STAFF RECOMMENDATION 134 Second Avenue North November 15, 2017

Application: Signage

District: Second Avenue Historic Preservation Zoning Overlay

Applicant: Andrew Chapman, Facility Solutions Group

Figure 1: 134 2nd Avenue North.
Front facade.

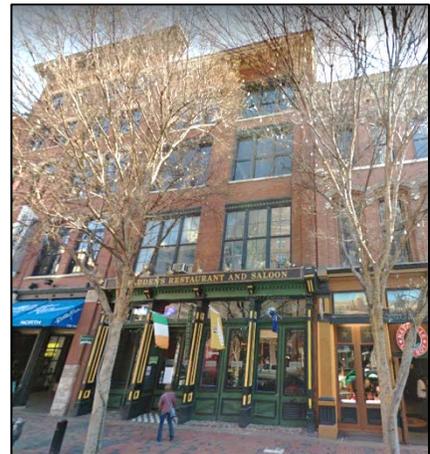
Location: The applicant is proposing painted signage on the rear or First Avenue façade, between the second and third story windows and between the third and fourth story windows, to be painted over existing non-historic signage. Staff finds the location of the proposed signage to be appropriate because it is on a secondary elevation and an upper-level location that does not cover architectural features. The two signs will cover existing non-historic painted signs.

Figure 2: Existing painted signage

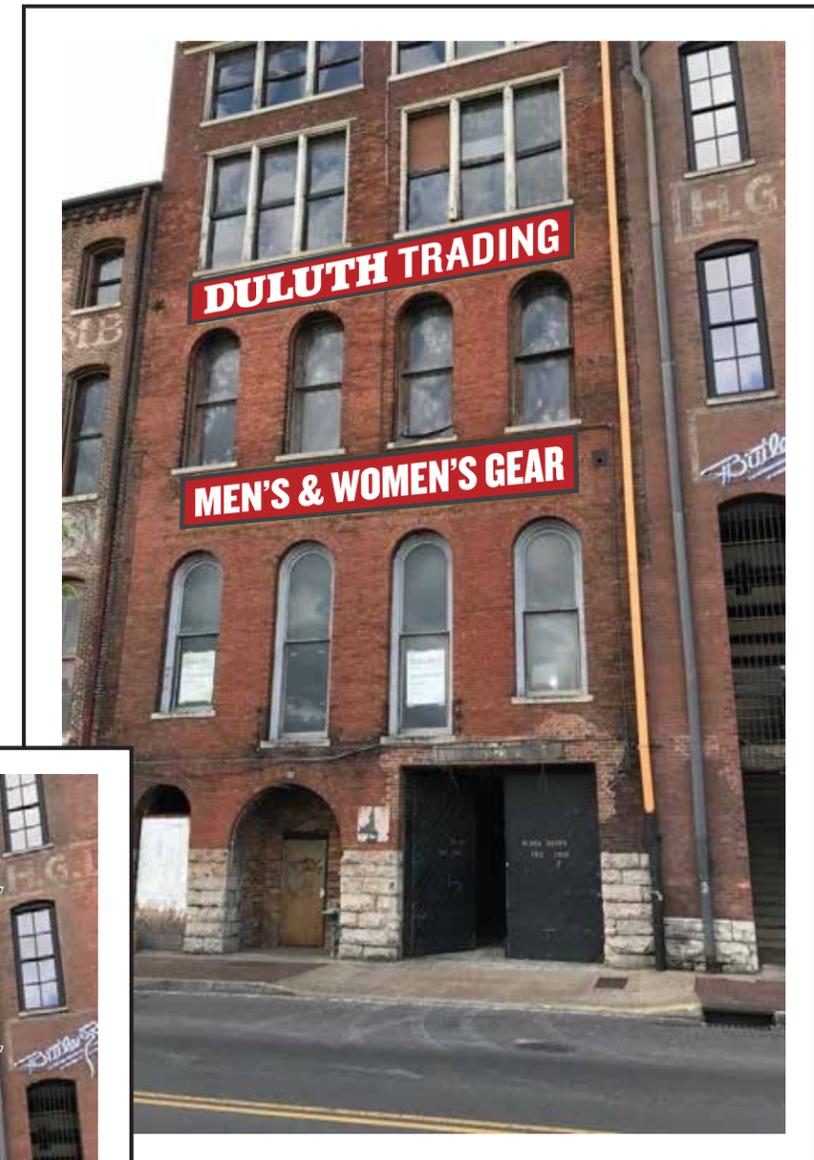
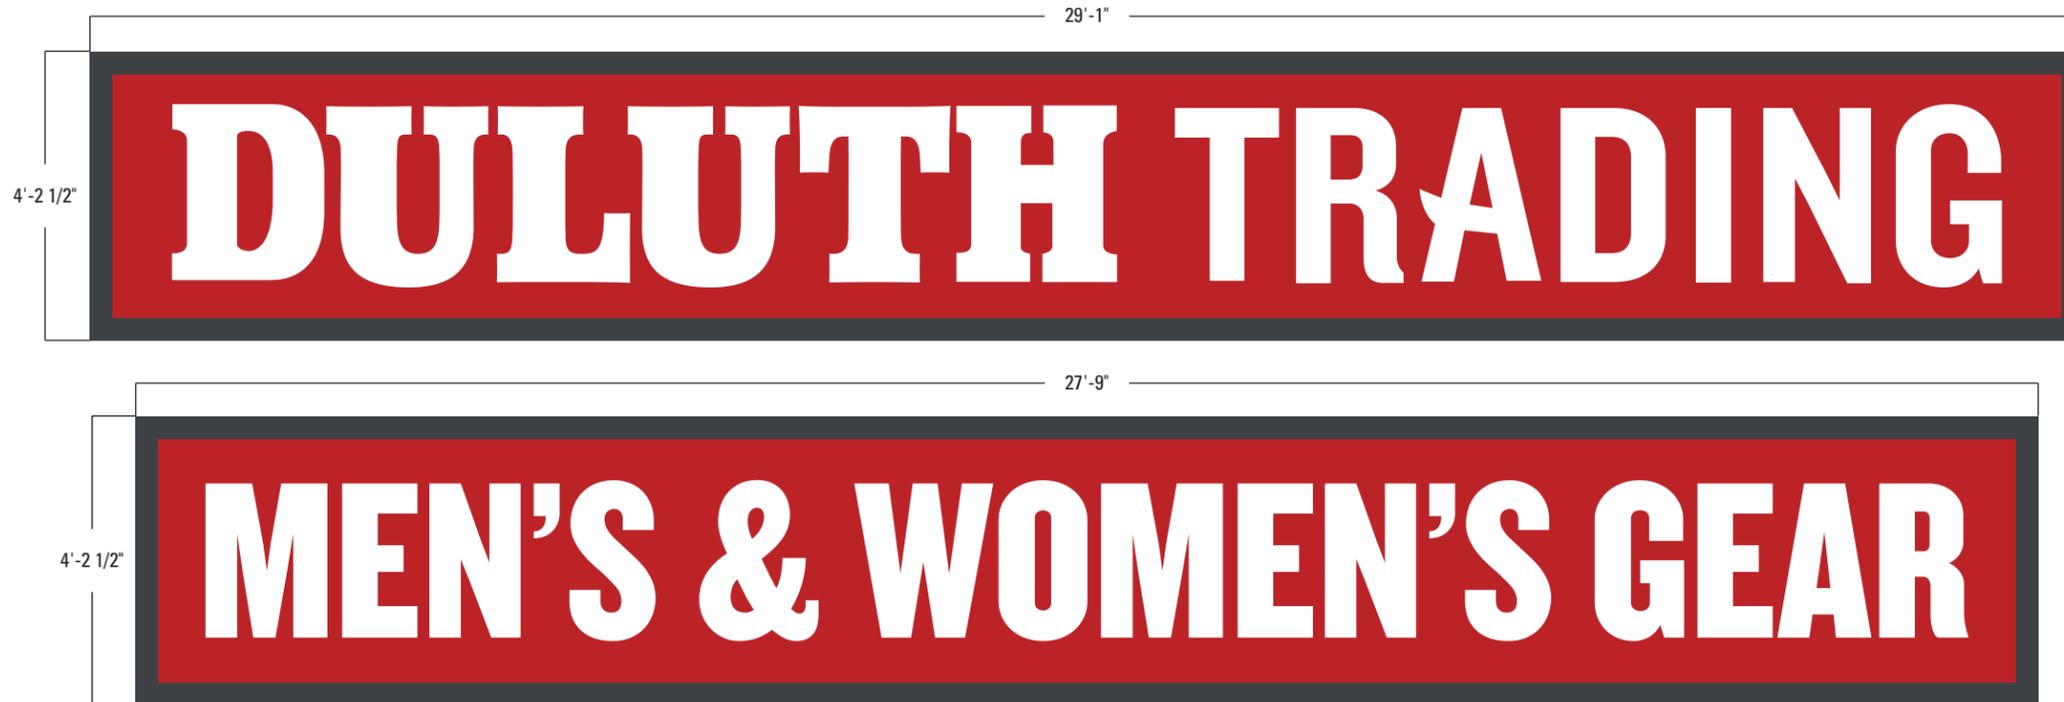
Size/Allotment: The design guidelines allow for one-hundred and twenty-five square feet of painted signage. The higher sign between the windows of the third and fourth stories will read “Duluth Trading” and a lower sign will read “Men’s & Women’s Gear”. The former will be one hundred, twenty-two square feet (122 sq. ft.) in area and the latter will be one hundred, sixteen square feet (116 sq. ft.) for a total area of two hundred, thirty-eight square feet (238 sq. ft.) of painted signage. The proposal exceeds the allotment of painted signage and so does not meet Section IV of the design guidelines. In the past, the Commission has considered existing signage when calculating total signage allotment. Additional square footage has been allowed when the project retains an existing historic sign; however, in this case, the existing signage is not historic.

Paint Removal: Because the existing painted signage is larger than the allotment, portions of the existing signage will need to be removed or painted over. Staff recommends final review of how removal will be accomplished to ensure that the process meets the design guidelines section II.M. for paint.

Recommendation Summary: Staff Recommends approval of new painted signage with the conditions that it not exceeds one hundred, twenty-five square feet in area and that the method of removal of the existing signage not covered shall obtain final approval from staff. With these conditions, Staff finds that the project meets section II for Rehabilitation and Section IV for signage.
